Submissions Report

Albion Park Quarry Extraction Area Stage 7 Extension

Application No. SSD 10369

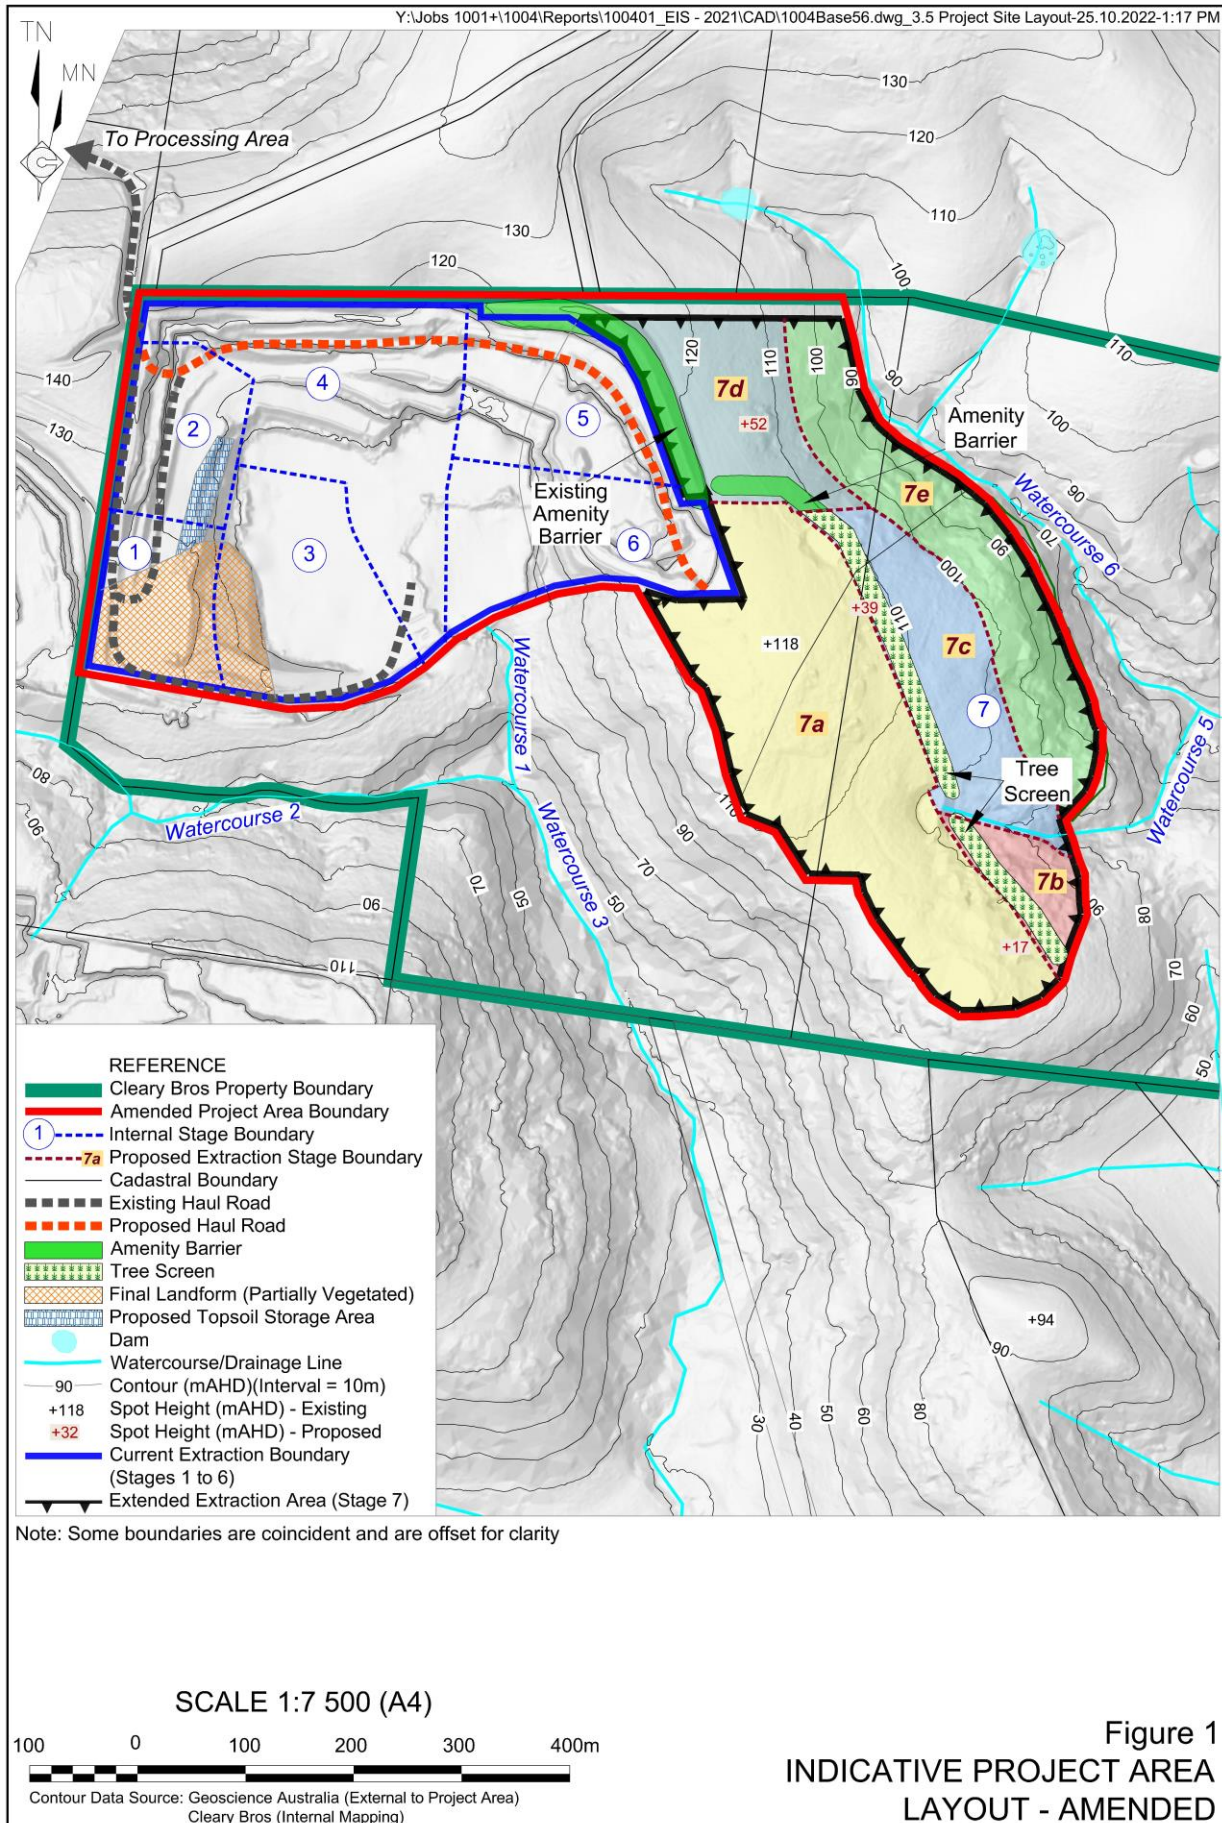
The additional information must consider a quarry progression plan and final landform achieved within a maximum 30-year timeframe. Other proposed amendments to minimise the impacts of the project should also be considered (e.g. biodiversity and visual).

- *Operational plans for extraction with operations ceasing at 30 years.*

This matter is addressed in Sections 3.3 to 3.5 of the *Amendment Report* as well as Sections 3.4.3, 3.6.2 and 3.9 of the amended Project Description. In summary, **Figure 1** presents the amended Stage 7 Extraction Area which has been reduced in size from 19.4ha to approximately 17.5ha. The reduced Extraction Area, together with depletion of the resource in Stages 1 to 6 between May 2019 and September 2022, has resulted in an amended resource estimate of 26.6Mt of latite and agglomerate. At a production rate of up to 900,000tpa, the life of the amended Project would be approximately 30 years

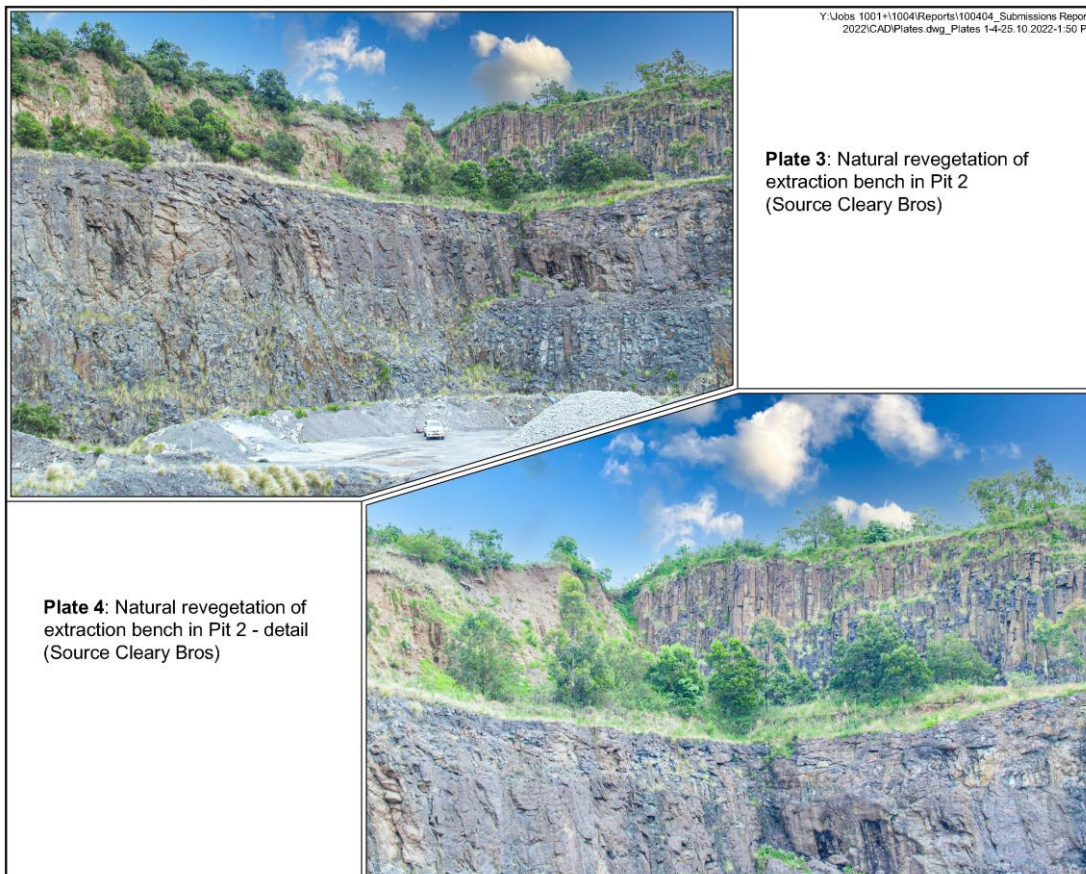
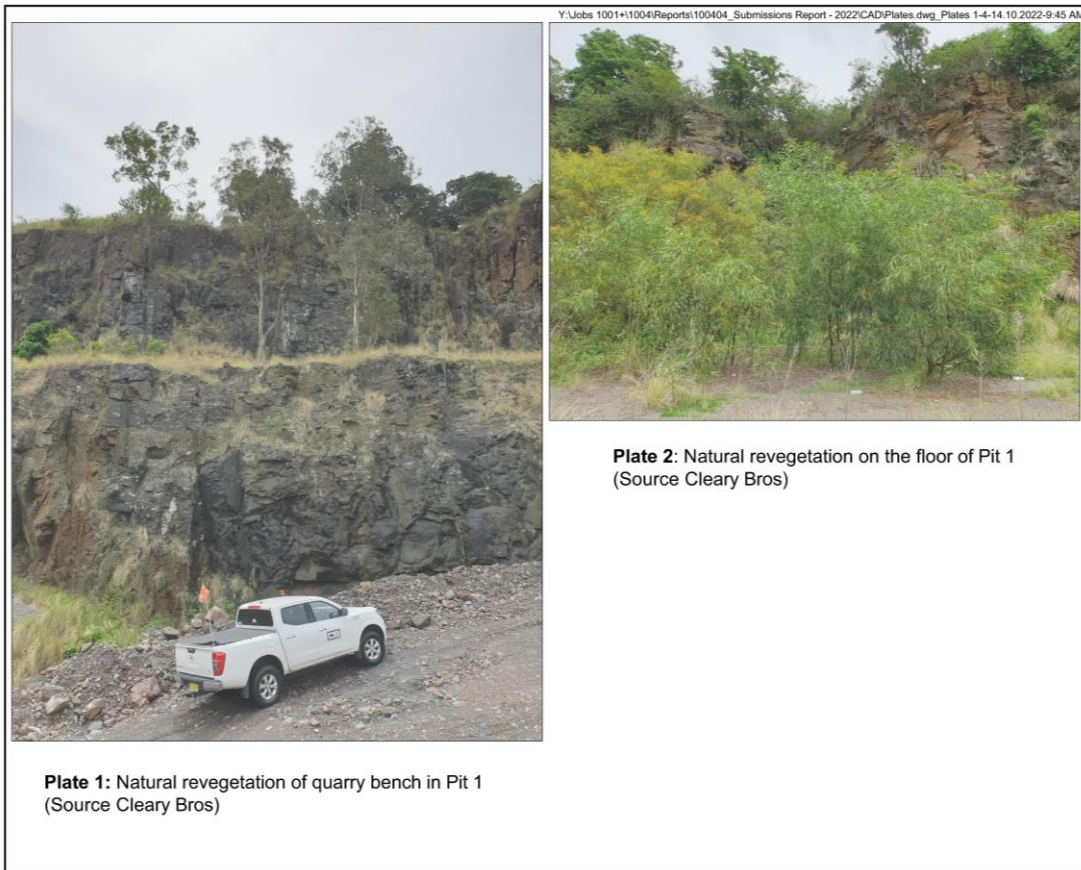
The EIS proposes the construction of a benched landform on the exposed quarry faces. The proposed landform would include 75-90 [degree] walls ranging from 7 to 14 meters high with benches ranging from 3 to 5 meters wide. The rehabilitation plan proposes vegetation on the benches to screen the exposed walls.

The Department considers there is limited justification/ evidence provided to support the conclusion that vegetation would be effectively established and maintained in the long term to provide visual screening of the exposed walls.

Cleary Bros notes the Department's comments in relation to challenges associated with rehabilitation of quarry benches. However, evidence of natural recruitment on similar benches within the Albion Park Quarry is evidence that the proposed rehabilitation of the highwalls is not only possible, but that it has a high probability of success. In summary, the Applicant has previously extracted material within Pit 1 and Pit 2 (see EIS Figure 1.3). No attempt has been made to rehabilitate these extraction areas at this point in time, with no soil or overburden spread and no active revegetation undertaken.

Plates 3 and 4 present views of the southwest corner of Pit 2 with well-established *Acacia*, *E. tereticornis*, and other species on the bench (likely *Pittosporum* and other rainforest species). It is noted that Pit 2 in this location is approximately 60m deep and that the upper face is assumed to be approximately 20m high. Again, the existing vegetation is growing in latite scree and talus from the face behind, with no overburden or soil spread on the bench.

Figure 7
VIEW FROM SITE 5
END OF STAGE 7D -
NO BENCH REHABILITATION

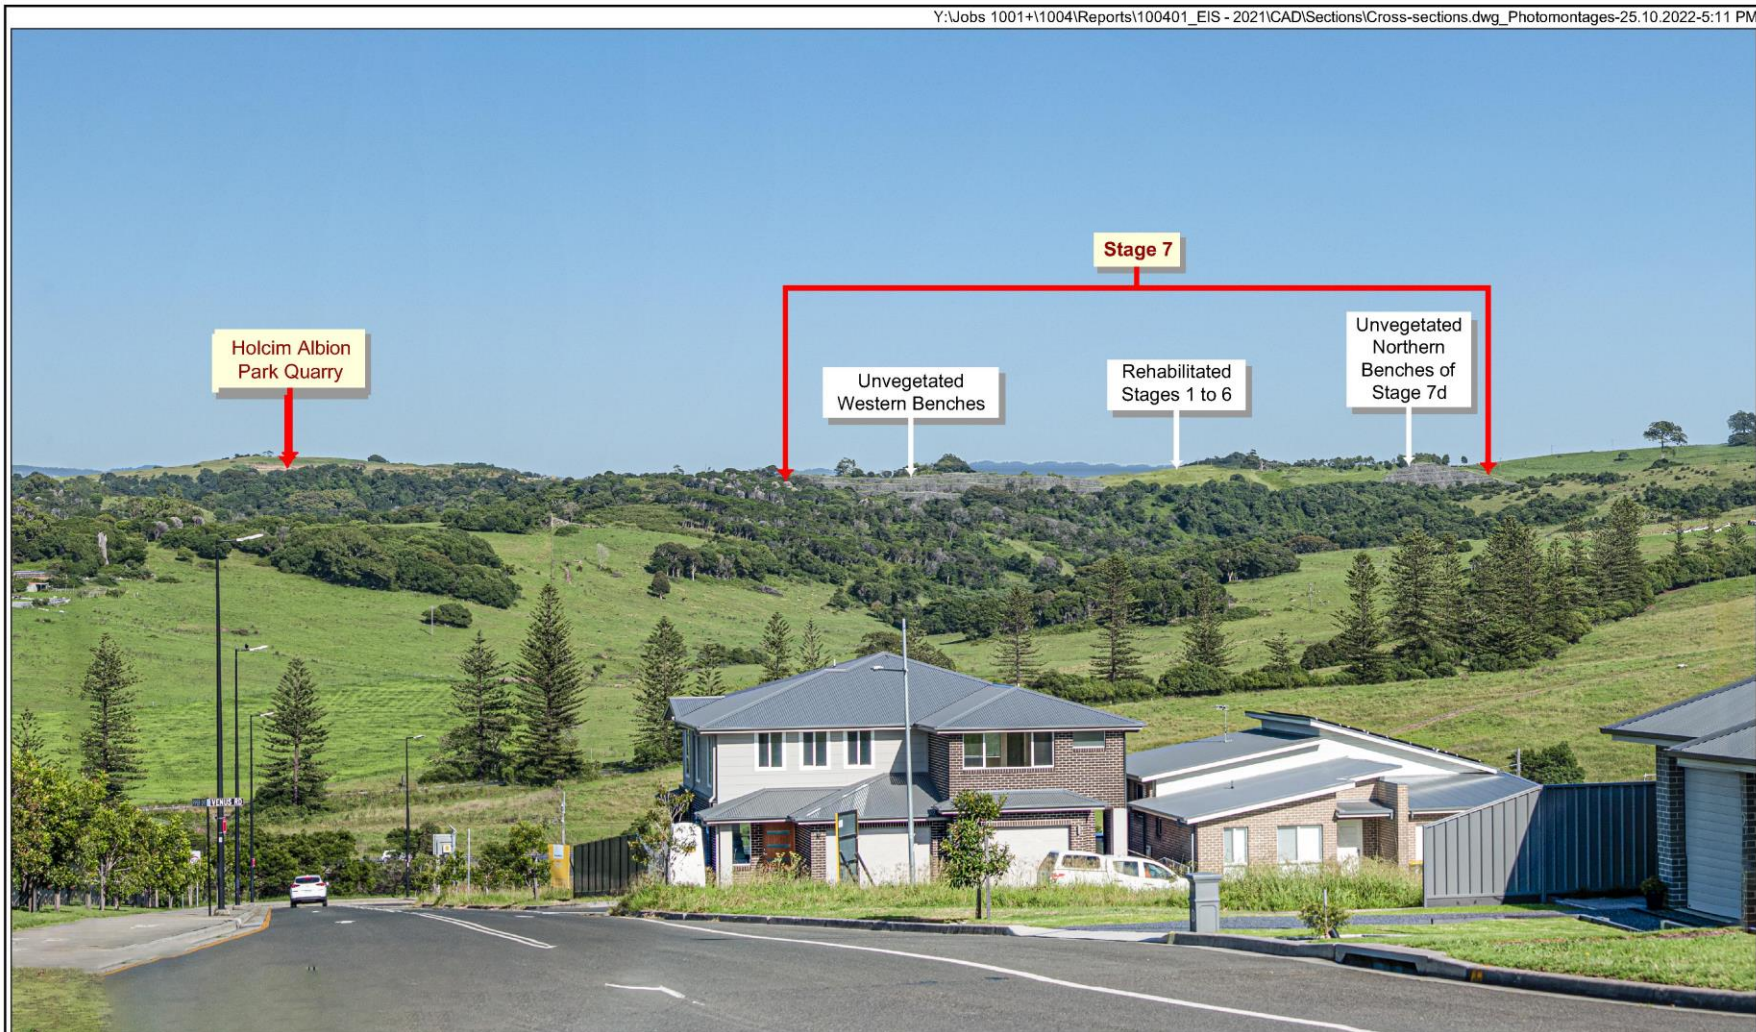
- *Assessment of alternative quarry designs which would limit the exposure of the quarry face to the east, including at a minimum consideration of a 30-year mine plan as discussed above (see comments above particularly in relation to the mine sequence identified in Figure 3.7 up to “commencement of Stage 7d”.*

Cleary Bros has committed to not commence Stage 7e unless the identified rehabilitation criteria for the western face of Stage 7a has been achieved. **Figure 7** presents a view of the amended Project Area from Site 5 with no bench revegetation and without expected natural recruitment (worst case scenario). In summary, limited views of the non-revegetated faces would be available. These views would be not dissimilar to views of the existing Holcim Albion Park Quarry. Views from other sites would be similar or less intrusive than those presented for Site 5.
